REGARDING **2-Year Warranty Review**

1844.40
The Bentley – Warranty Review

08 May 2007

Photograph 1.5	Photograph 1.6

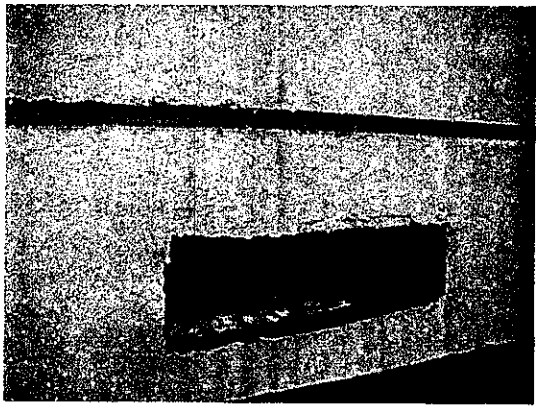
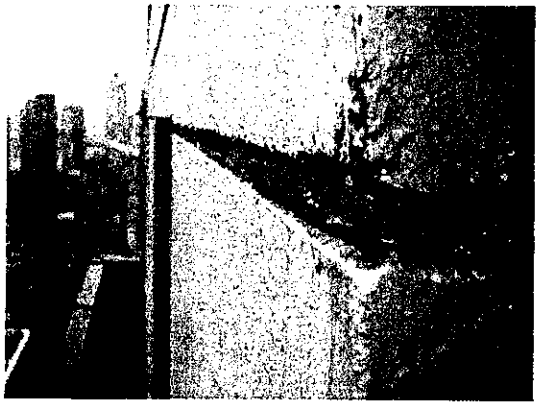
Observation: The urethane balcony membrane was not removed before the Allguard was installed. The Allguard is not bonded to the runs of urethane deck membrane.	**Observation:** Sealant was not installed above the light – Suite 406.
Action Required: Grind off excess urethane – reapply Allguard.	**Action Required:** Apply a bead of neutral cure silicone sealant above the light – leave weep hole at base.

Photograph 1.9	Photograph 1.10

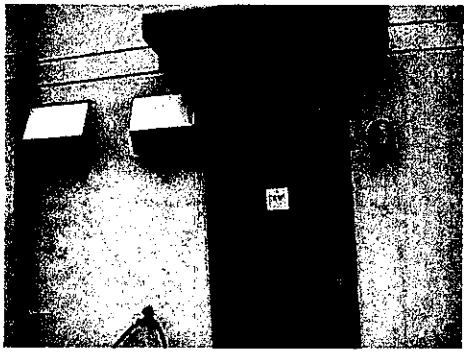
Observation: Allguard paint is discontinuous	**Observation:** Numerous vents are plugged.
Action Required: Ensure all areas are painted per project specification.	**Action Required:** Owners should be cleaning vents regularly as outlined in Maintenance Manual.
